**KNOXVILLE/KNOX COUNTY METROPOLITAN PLANNING COMMISSION  
SUBDIVISION REPORT - CONCEPT**

▶ **FILE #:** 3-SC-13-C

▶ **SUBDIVISION:** KINGSTON CORNER

**RE: Kingston Corner, SR-1 with Cedar Bluff Road  
Knox County**

C3.0

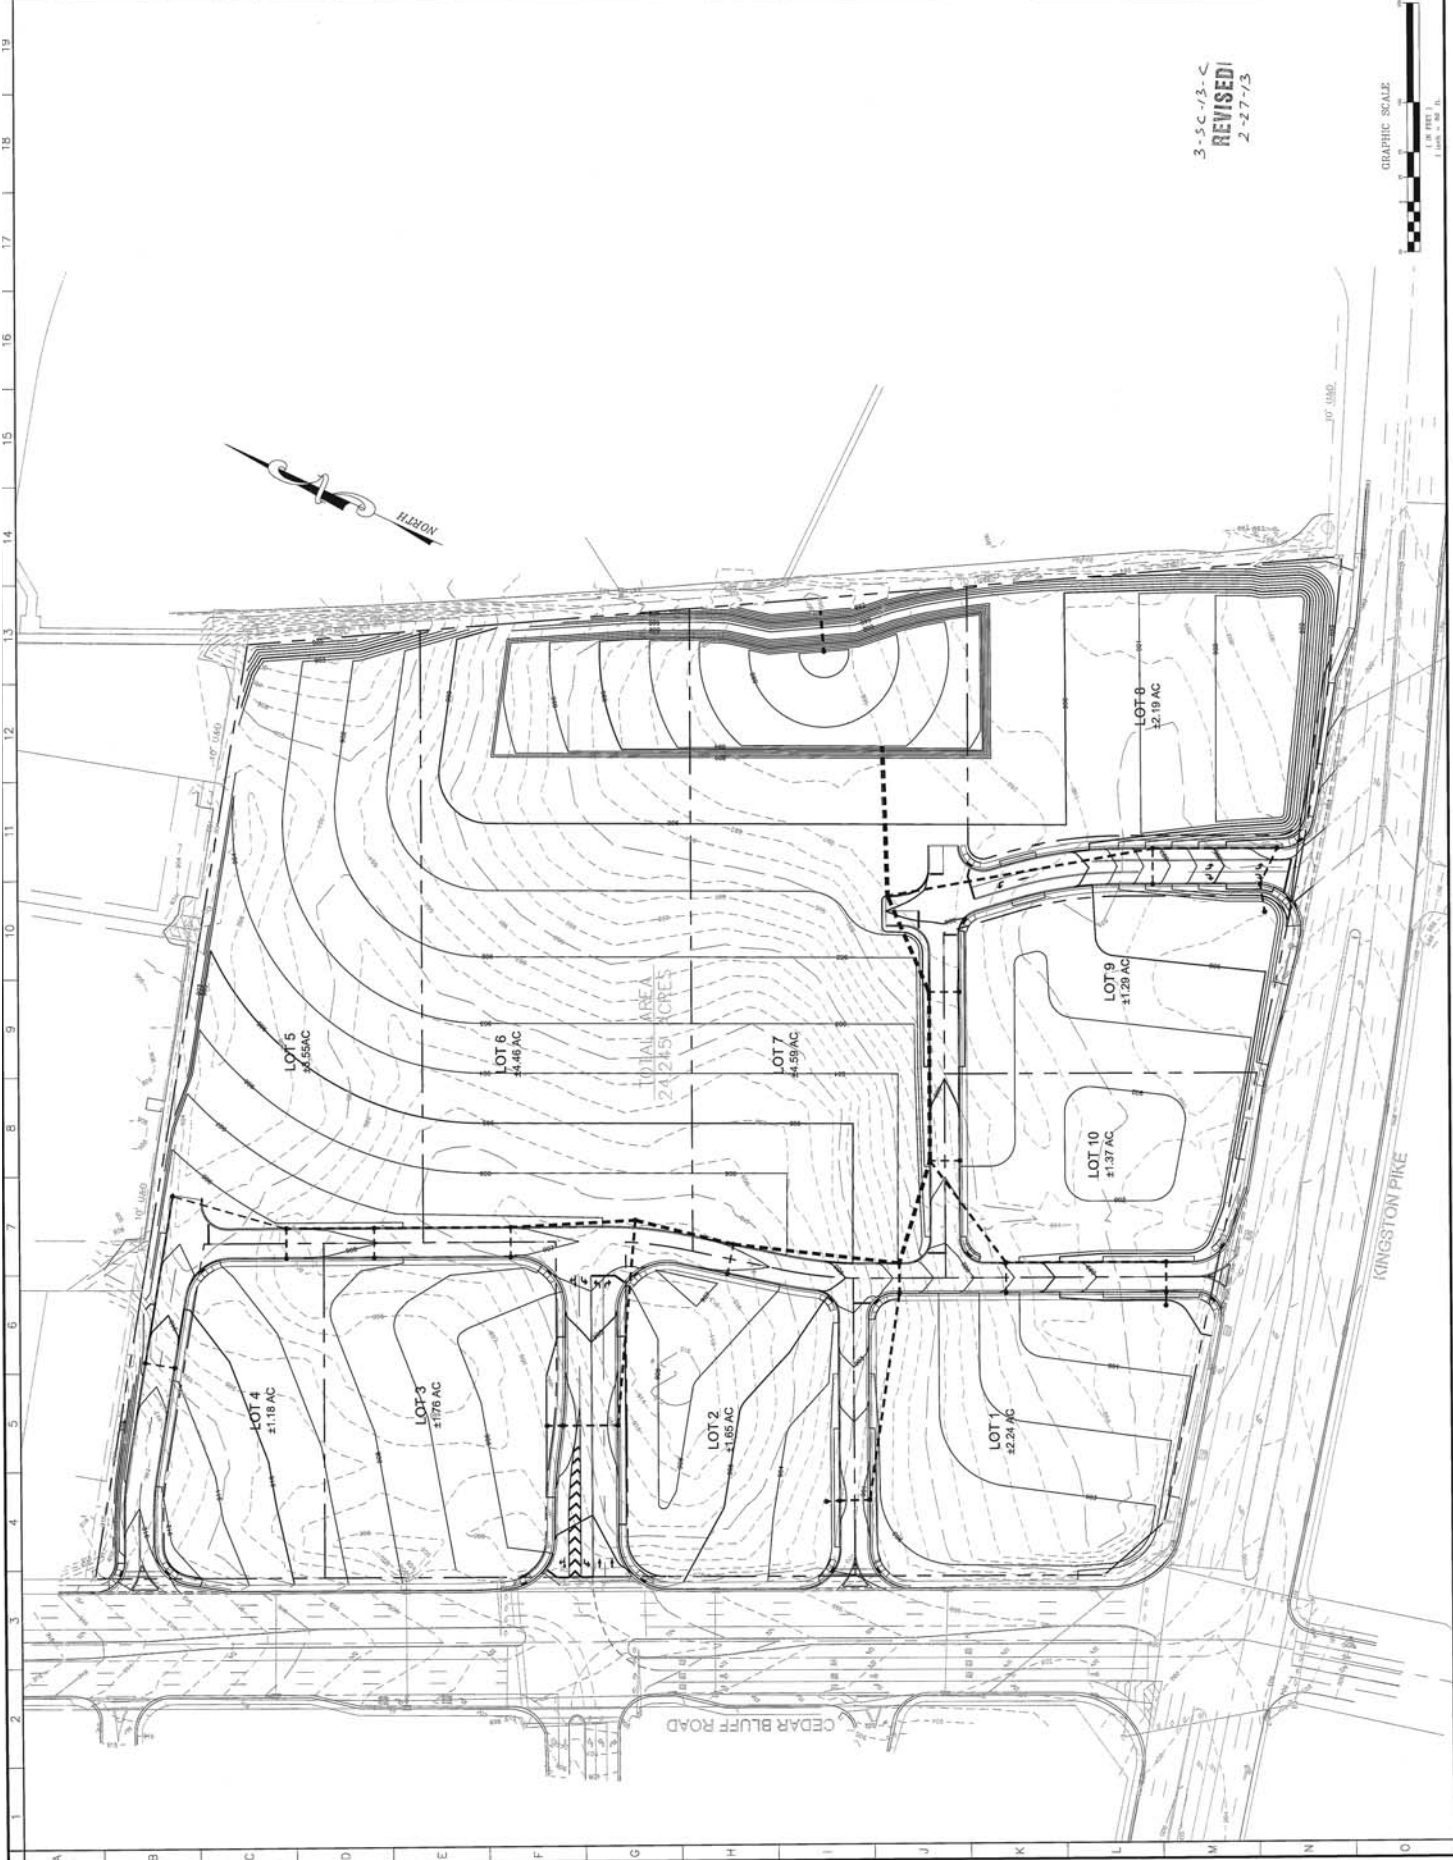
Based upon our review, the overall proposed access to this property may be considered excessive in relations to the size of the development and trip demand. While the design may be attractive for the individual subdivision of parcels, it creates unnecessary conflict points and will likely be problematic due to existing auxiliary lanes and required crossing distances. Due to these issues, the current configuration is not recommended as currently planned.

Traffic attempting to make left turns from the site onto Kingston Pike would have a crossing distance of 70 feet to reach the median refuge, which is only 12 to 14 feet wide and would not be sufficient for storing vehicles that attempt this maneuver. This crossing distance and the posted speed on Kingston Pike would require an intersection sight distance of 685 feet to allow for the required time gap, based on AASHTO standards. It is recommended that this traffic utilize the existing signalized access on Cedar Bluff and signal at Kingston Pike instead. Additional factors including queuing and the sheer volume along Kingston Pike would make this movement more difficult and potentially hazardous. Additional lanes should be added to the signalized access on Cedar Bluff so that this access could support this additional traffic load.

The proposed access is located in the middle of an auxiliary lane for westbound Kingston Pike traffic turning right onto northbound Cedar Bluff. TDOT does not recommend access in auxiliary lanes, especially when other accommodations could be made for access. In addition to this issue, exiting traffic potentially would be required to cross five (5) lanes if attempting to turn left onto S. Cedar Bluff Road. Therefore, this access is not recommended at this time. A single point of access should be considered along Kingston Pike so that these concerns are minimized and access is provided. Due to the location of existing traffic signals and their associated queues additional signalization along Kingston Pike is not recommended for this access. Due to all the factors listed above, left turn egress from the site at the access would not be allowed.

The proposed access is located approximately 280 feet downstream from the intersection of Kingston Pike. NCHRP Report 659, "Guide for the Geometry Design of Driveways" provides the following guidance for the placement of entrances, "*The spacing for a driveway of the departure leg of a signalized location on a major road should be sufficient to minimize the adverse effects... it suggests the downstream corner clearance should be no less than the stopping sight distance*". In our case, SSD at 40 mph = 305 feet or SSD at 45 mph = 360.

If the access is allowed additional consideration should be given to lane utilization on northbound Cedar Bluff and further mitigation should be considered including a deceleration lane. Given that the outside lane serves traffic entering the eastbound and westbound interstate ramps, this lane experiencing more traffic at times when compared to the other lanes through lanes.

As currently designed, the lane configuration would require the signal to operate in split phase operation, which would work very well for the minor street approaches. However, this would result in additional lost time and less green time for the major roadway movements. This would decrease the capacity of Cedar Bluff Road and increase delay for through traffic. Due to these issues, the current configuration is not recommended as currently planned. Additional lanes should be provided and modification to the Kroger access should be made to properly facilitate traffic and thus eliminating the need for split phase operations.

The proposed access is located within the influence area of the signalized intersection of North Peters Road. The northbound queue extends to the proposed location frequently and additional consideration should be given to this issue.

1. Connection to sanitary sewer and meeting any other relevant requirements of the Knox County Health Department.
2. Provision of street names which are consistent with the Uniform Street Naming and Addressing System within Knoxville (City Ord. 0-280-90) if required.
3. Revising the concept plan to comply with the recommendations from the Tennessee Department of Transportation (TDOT), as identified in the attached letter dated March 6, 2013, for the proposed access on Kingston Pike. This includes the elimination of the right-in/right-out driveway between Lots 1 and 10, and

removal of the left turn movement exiting the site between Lots 8 and 9. The revised concept plan shall be submitted to the Planning Commission staff for approval within 30 days from the concept plan approval by the Planning Commission.
